Composite Laminate Tool v3: progressive failure and validation status

Report No. 2 · 7 October 2026 · Author: Artem · App: <https://composite-laminate-tool.streamlit.app/> · Code: <https://github.com/Artyom09062002/composite-laminate-tool>
Educational and screening tool. Not a certified design calculation.

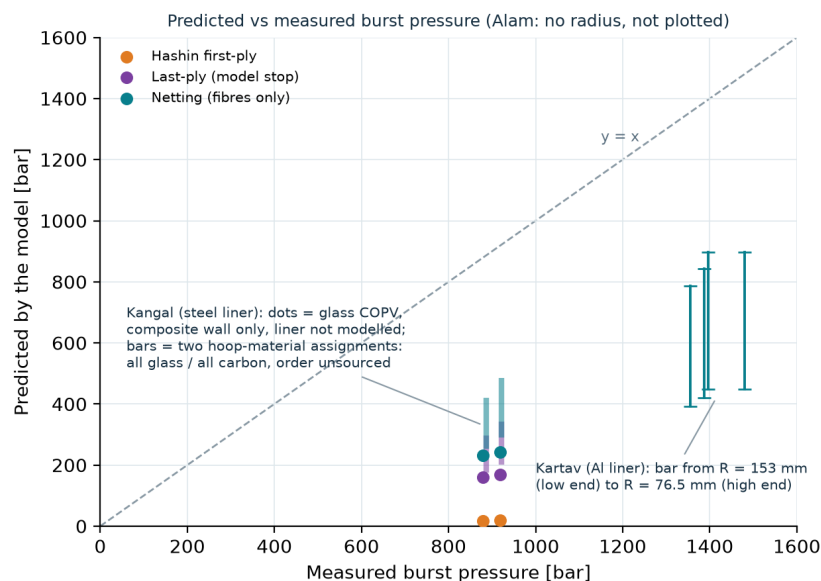
Finding (confirmed)	Consequence found by test	Action
Pure in-plane shear with $\alpha = 1$ gives $FT = MT = 1$	Progressive model degraded fibres and matrix in all plies of a UD laminate under pure shear (8 events, $E_1 \times 0.01$ with no fibre stress)	Initiation unchanged; a fibre-tension index driven by its shear term is applied as matrix damage (documented choice, not validated)
$S_T = Y_c/(2 \tan 53^\circ)$ is not a measured property	The check $MC = 1$ at $\sigma_2 = -Y_c$ holds for any S_T ; the default (92.7 MPa) exceeds $S_{12} = 68$ MPa for T300/5208	Marked ASSUMED in every result; S_T varied as sensitivity
"Last-ply" read as an ultimate load	All residual stiffnesses stay positive; no stability check; load factor never reduced	Renamed "model stop"; held steps flagged

Finding (confirmed)	Consequence found by test	Action
Stopping and new failures at the same load	New failures at the stopping load were dropped from the failure list	Single batch rule, tested
